**OBJECTION TO DEVELOPMENT APPLICATION DA2024/1707**

18 HILLCREST AVE MONA VALE - DWELLING [24\_066]

Re: Building impact on Norfolk Pine at  
No. 18 Hillcrest Ave Mona Vale 2103

1 PROPOSED GROUND FLOOR PLAN 1:100

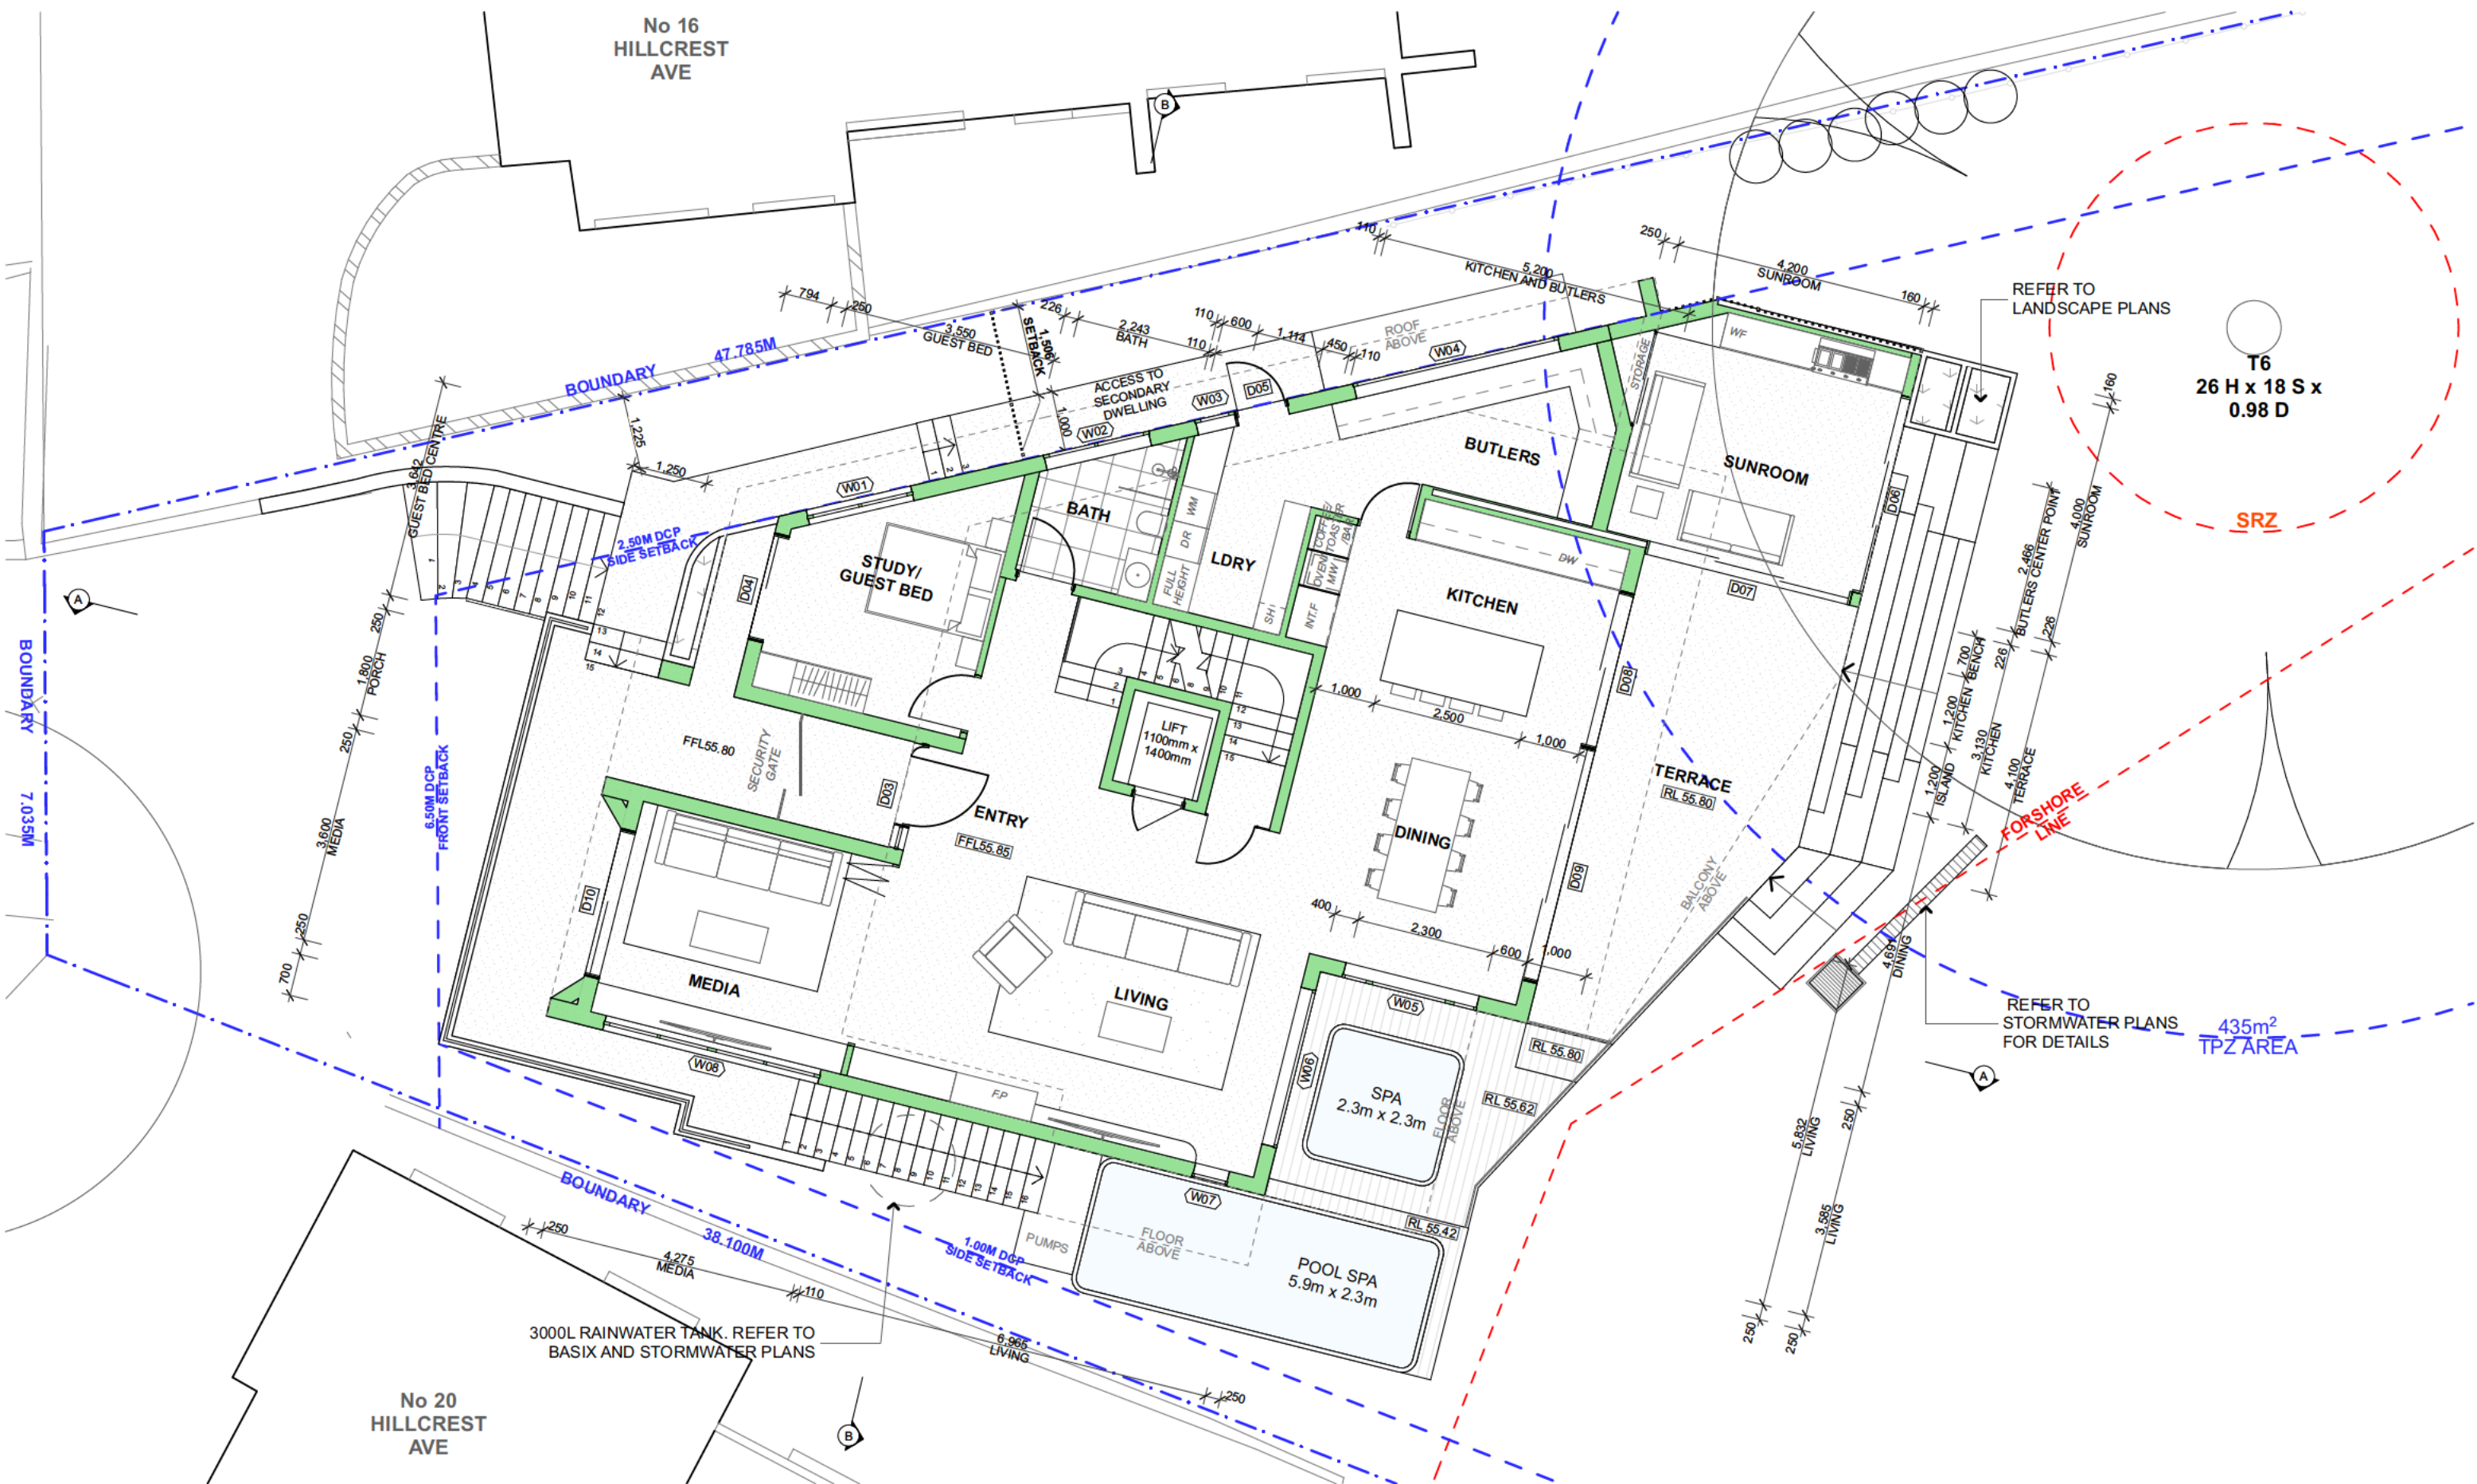
The proposed sunroom and covered roof terraces extend significantly into the tree protection zone and the canopy of the Norfolk Island Pine. This includes construction of concrete strip footings to support the stone walls (shown on the north elevation) and concrete stairs shown on the southern elevation.

I believe that the subject tree will be impacted by the construction of the proposed dwelling, specifically the sunroom and terrace with concrete stairs attached to the house, as these elements are currently proposed to be built within 7 metres of the trunk of said Norfolk Pine. The arborist report page 6 has categorised the encroachment on the TPZ of the proposed building as major and visually demonstrated this in figure 1.

The proposed development should be amended to set back further from the Norfolk Island Pine mostly outside the tree protection zone.

The structures should be reduced so that the canopy of the tree does not need to be reduced.

- The sunroom be removed
- The terrace and stairs be scaled back

1 PROPOSED FIRST FLOOR PLAN 1:100

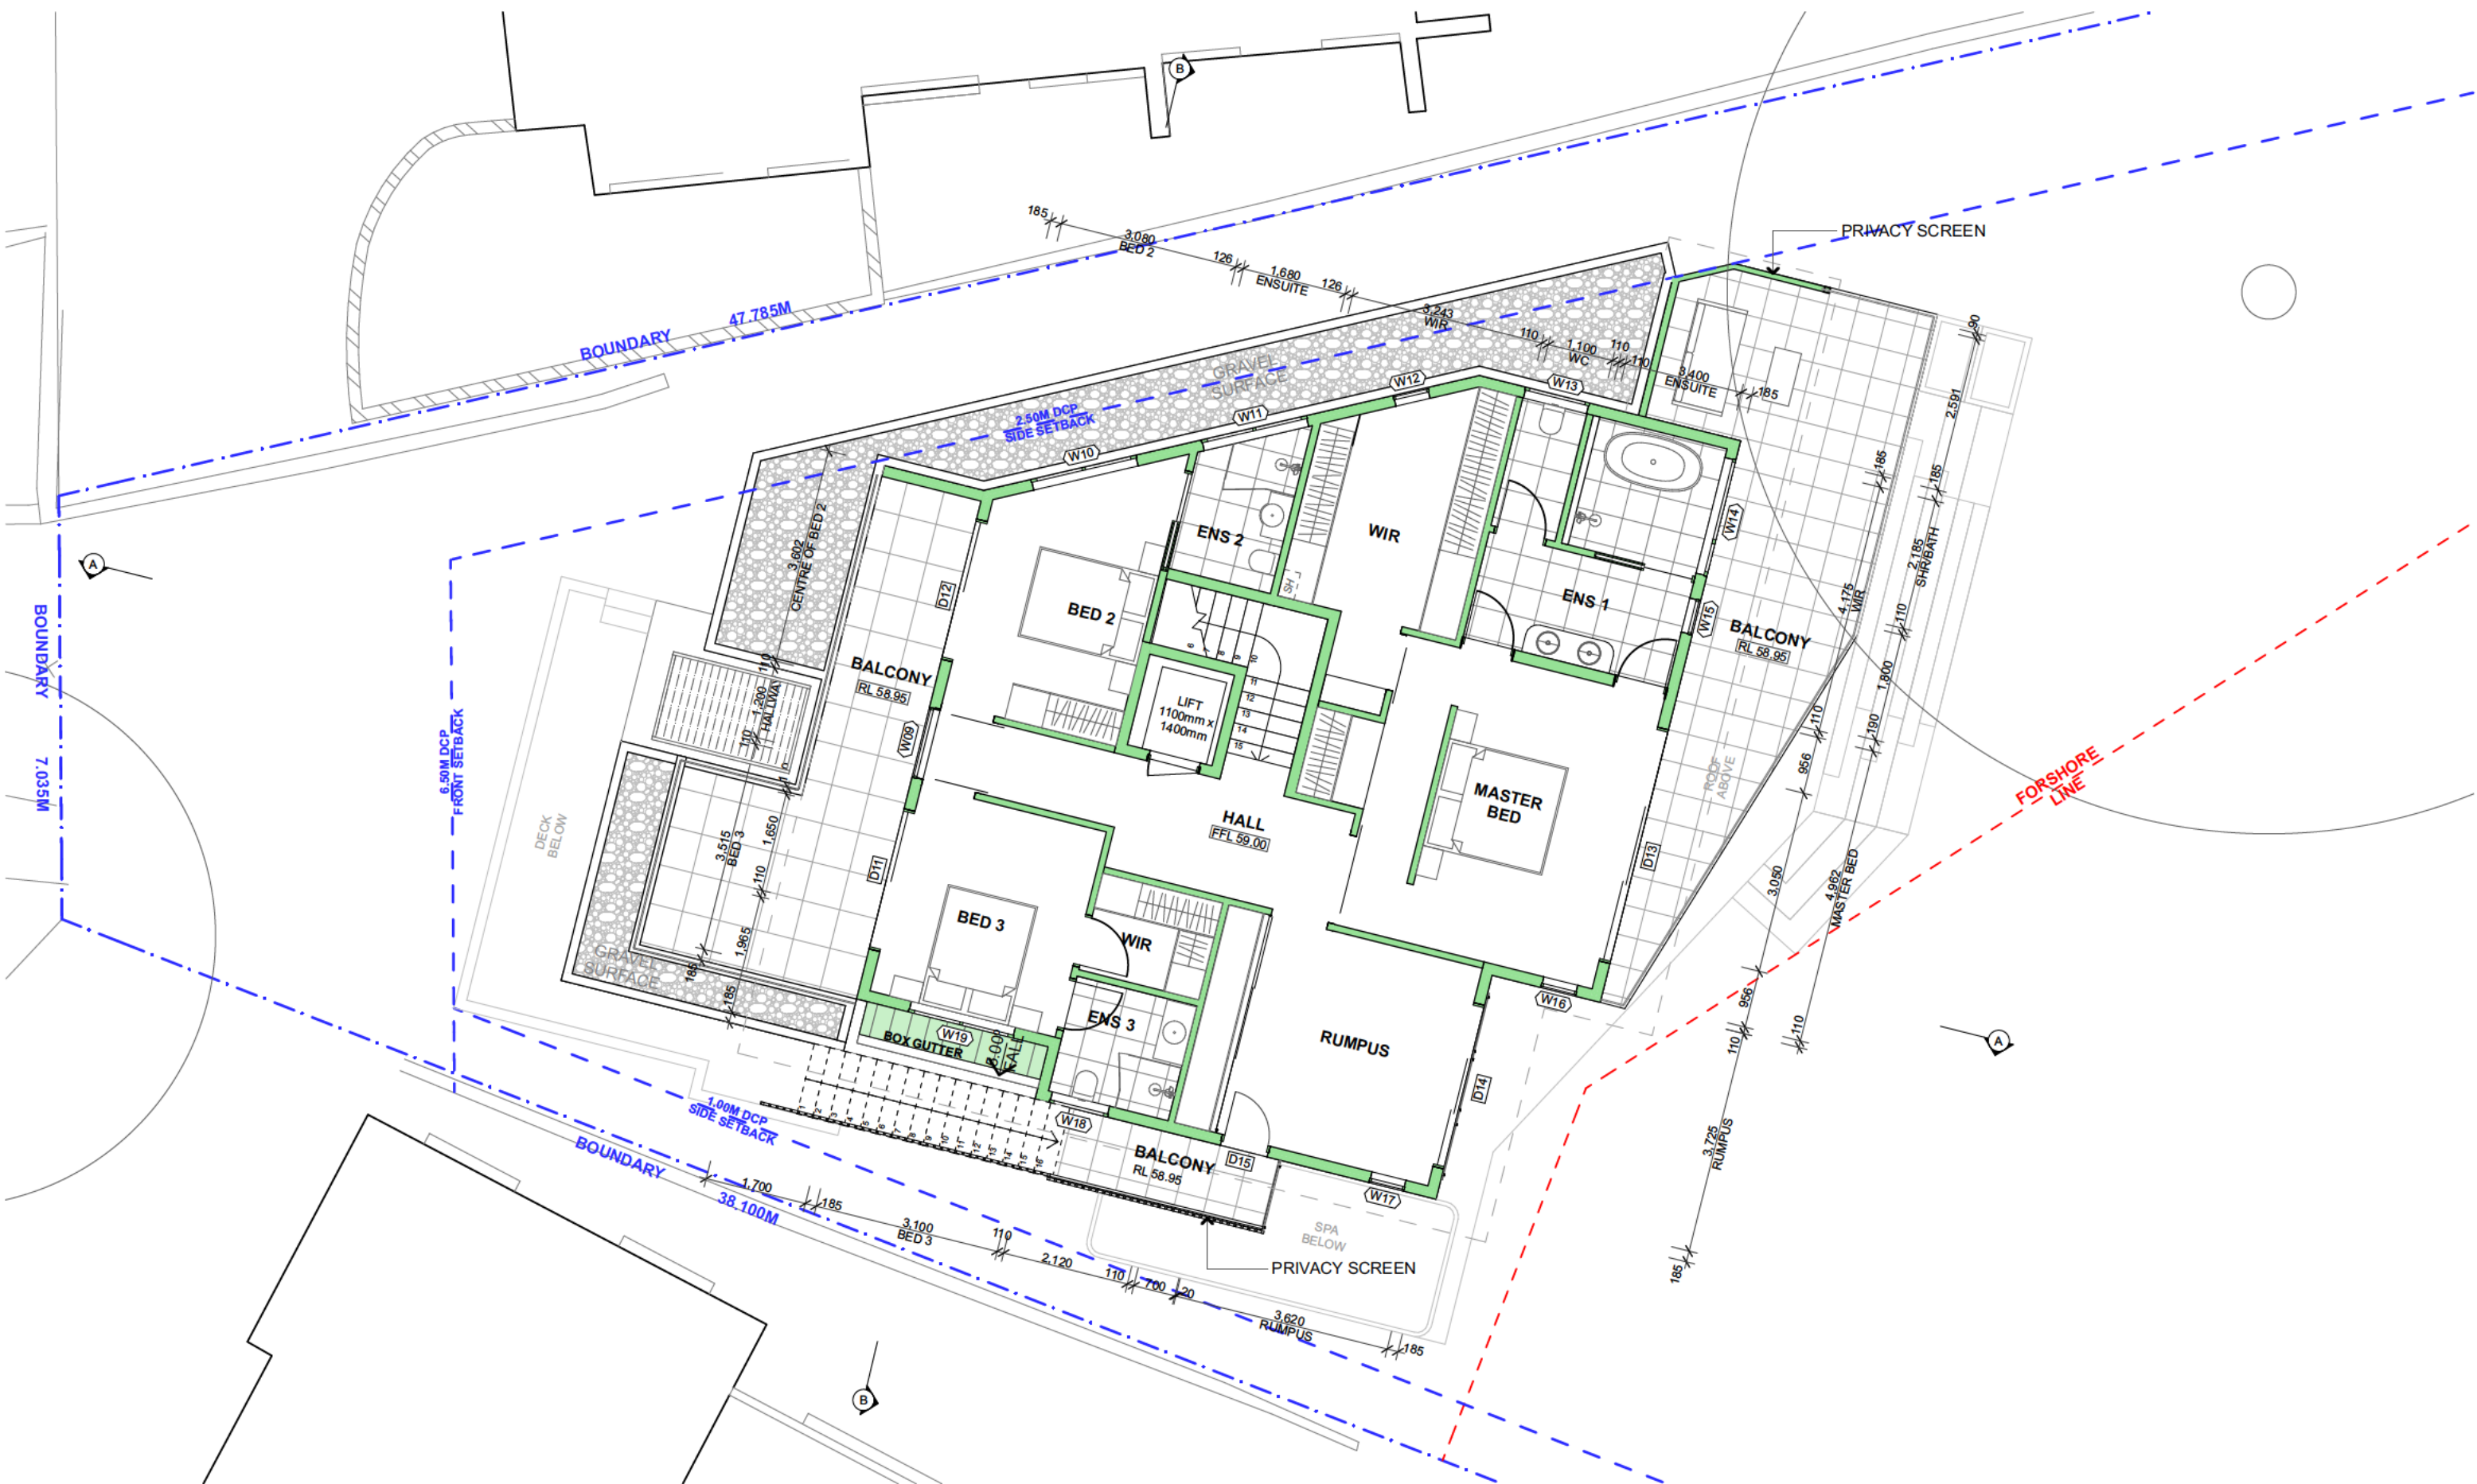
The proposed development appears to completely obstruct view from these windows. There has been no analysis undertaken within the application to demonstrate what the views are, the extent to which these views would be obstructed, or how the views have been shared.

The views to the ocean are considered to be iconic views from this upper-level living room. The primary obstruction to views include the proposed ensuite and privacy screen that surrounds the upper level balcony

Views to the ocean are also currently available from the upper level balcony. It is anticipated that these eastern views will be completely obstructed by the proposed development.

We request that the development be amended so that a view corridor is provided from the living room windows to the southern side of the Norfolk Island Pine. This will require:

- Deletion of the privacy screen and habitable balcony adjacent the ensuite
- Amendment to the ensuite and walk in robe, and master bedroom
- Reduction in the extent of ground floor structures

The suggested view corridor to be retained is to see the ocean to the north of the existing pole at the end of the deck and Norfolk Island Pine.
